# REPLAT OF PART OF KINKAID PARK

Date: SEPTEMBER 19, 2003  
"Replat of KINKAID PARK"  
FINAL PLAT SHEET 1 OF 1

RE: SUB 2003-71 - One-Step Final Replat of Kinkaid Park Addition

**CASE NUMBER:** SUB 2003-71 -- REPLAT OF KINKAID PARK ADDITION

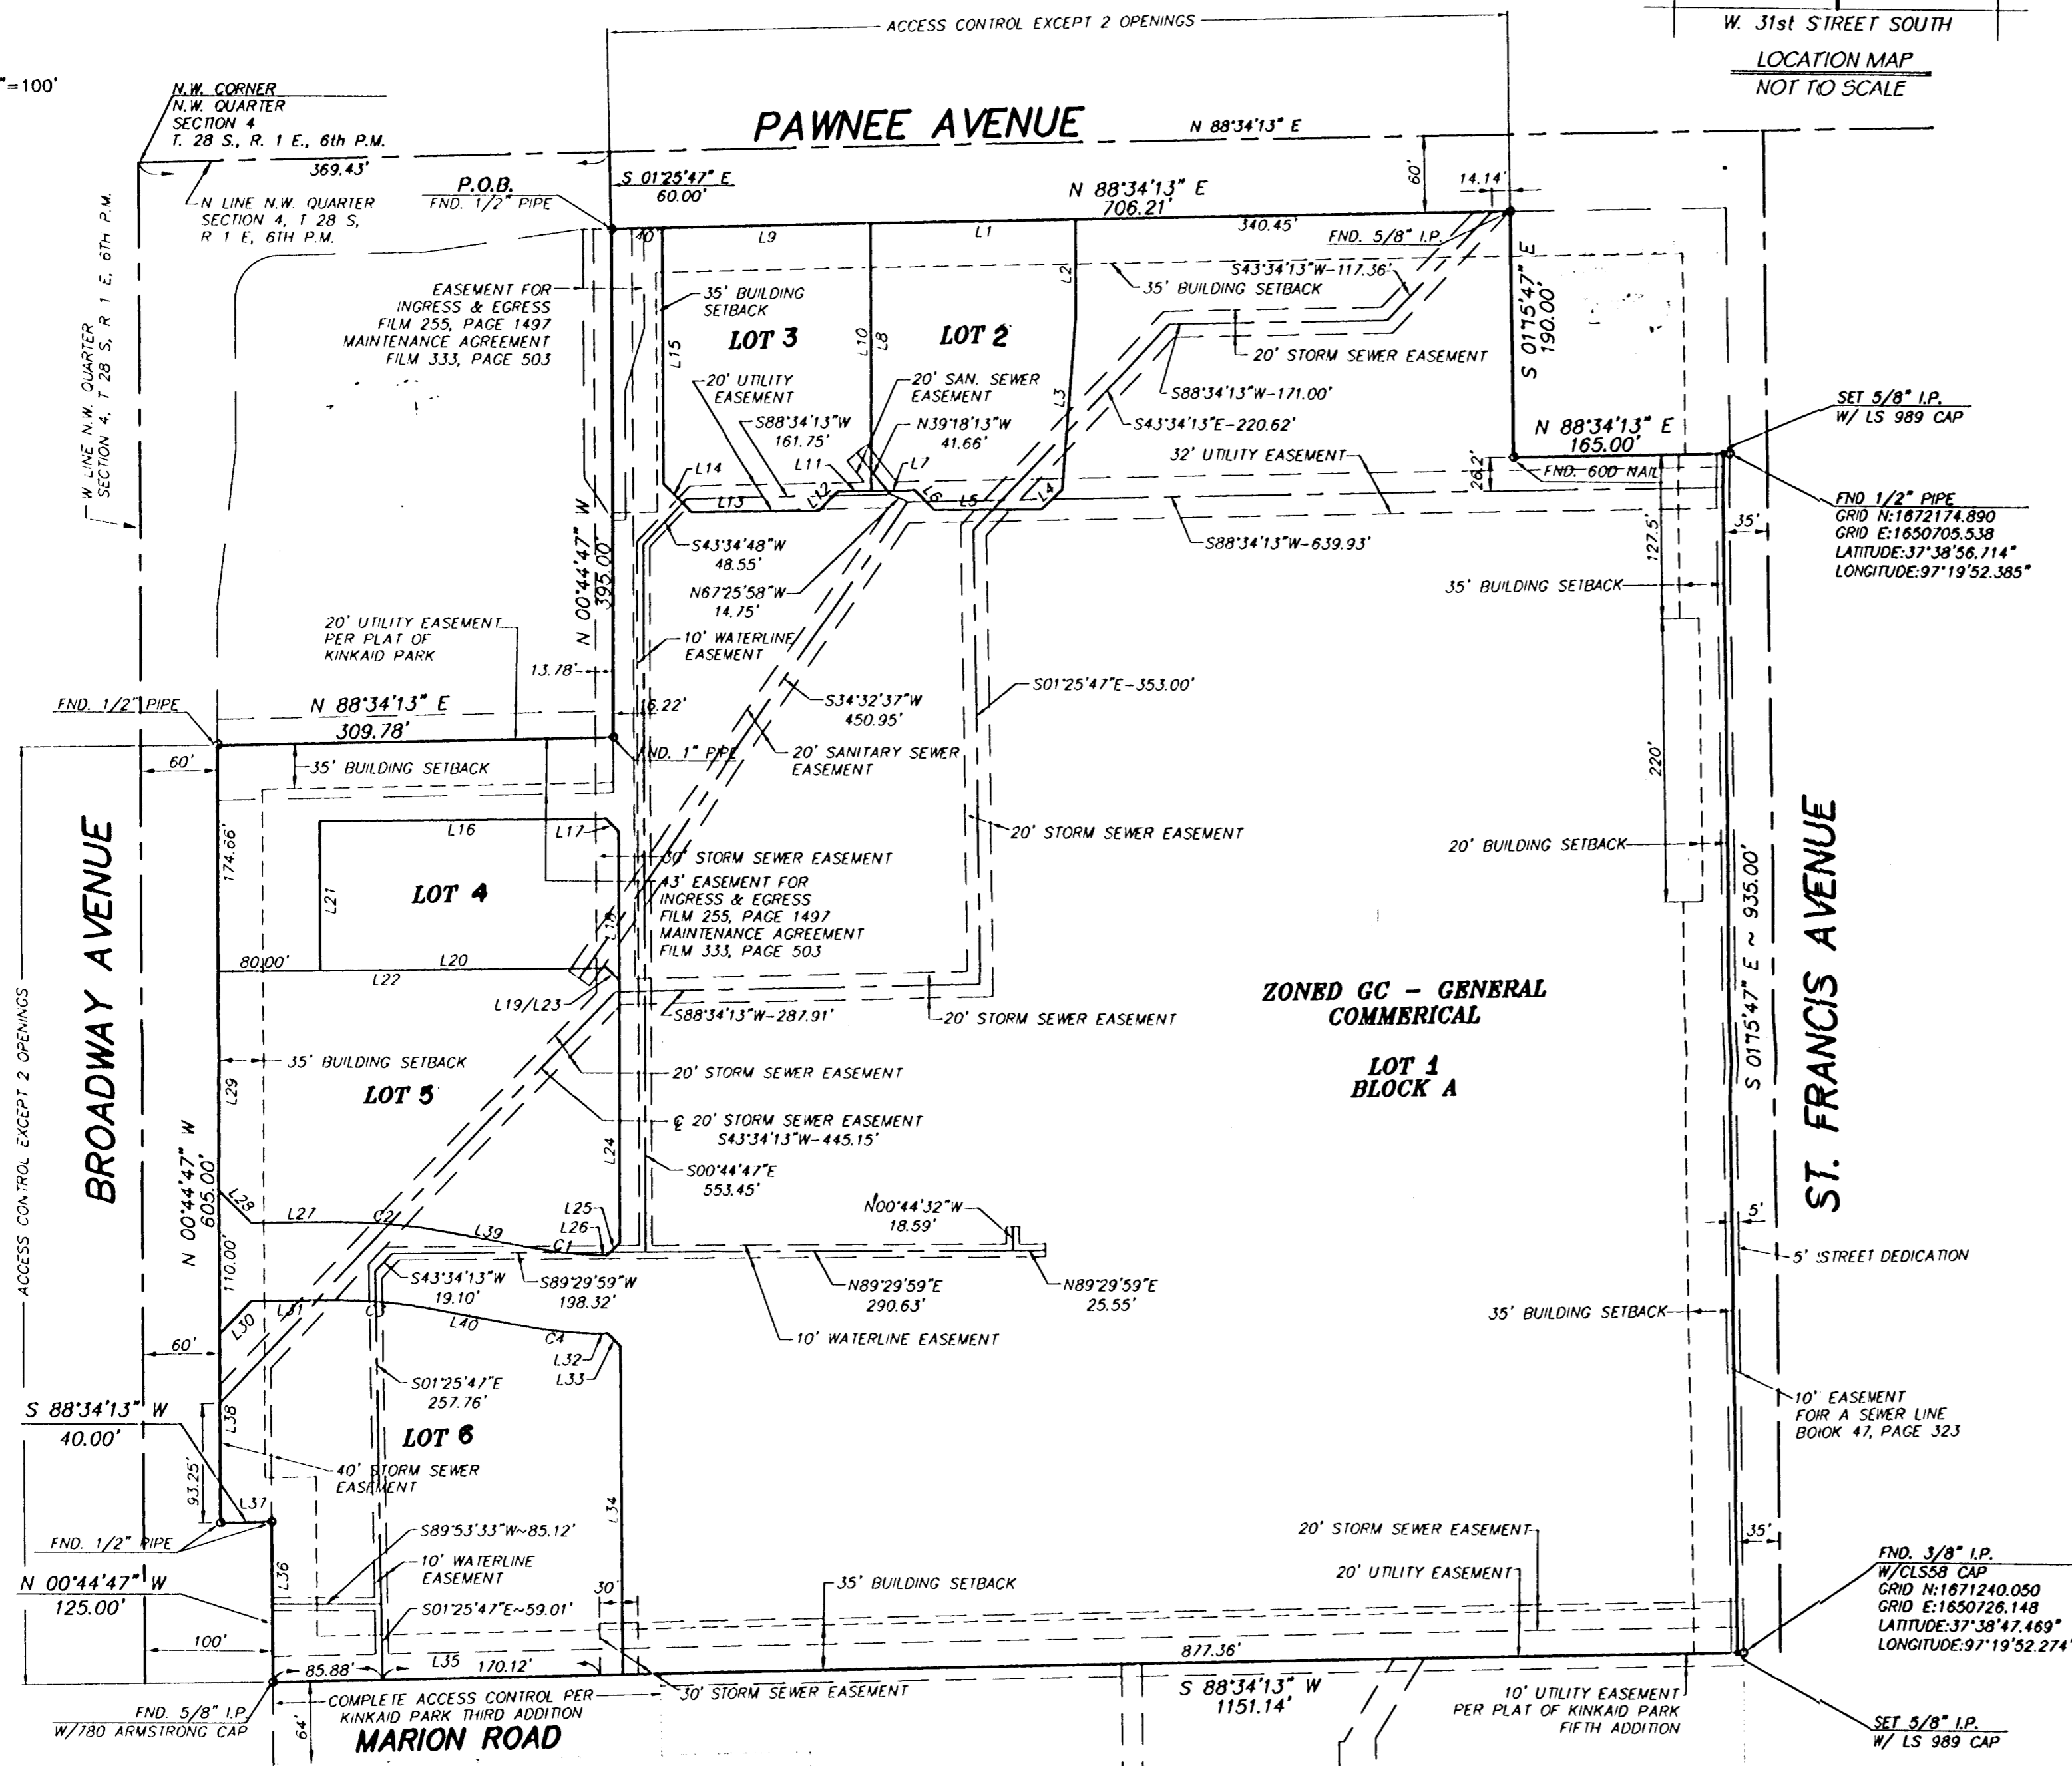
- A. City water services are available to serve the site. The applicant shall guarantee the extension of sanitary sewer to serve the lots being platted. Utility easements for water services need to be platted.

- C. A guarantee for the sewer abandonment will be required.
- D. The 10-ft sewer easement needs to be increased to 20 feet and extended to serve Lot 2C.

- J. County Surveying has requested a central angle (delta) with curve data.
- K. The 20' portion of building setback along the east side of Lot 2A needs to be located.

- N. County Surveying has requested a bearing on internal lot lines.
- O. County Surveying has advised that the storm sewer easement along the south line of Lot 2A needs to be located. (20' north of south line)

- P. County Surveying has advised that the 10' sanitary sewer easement running southwest-northeast needs to be located.
- Q. County Surveying has advised that interior bearings need basis shown since some are plat and some are SPCS.

- R. The lot lines need to be solid lines.
- S. In accordance with the CUP amendment, a cross-lot circulation agreement is needed to assure internal vehicular movement between the lots.

- T. Traffic Engineering has requested additional right-of-way along St. Francis. The Subdivision Regulations require a 35-ft half-street right-of-way for a commercial street.

- U. The lots shall be renumbered as 1 through 6, Block A.
- V. A note shall be placed on the final plat, indicating that this Addition is subject to the conditions of to the Kinkaid Park Commercial CUP (CUP 2003-19, DP-43 Amendment #3).

- DD. Marion Rd. which abuts the plat to the south, shall be designated on the plat along with its right-of-way width.
- EE. The Applicant is reminded that a platting binder is required with the final plat. Approval of this plat will be subject to submittal of this binder and any relevant conditions found by such a review.
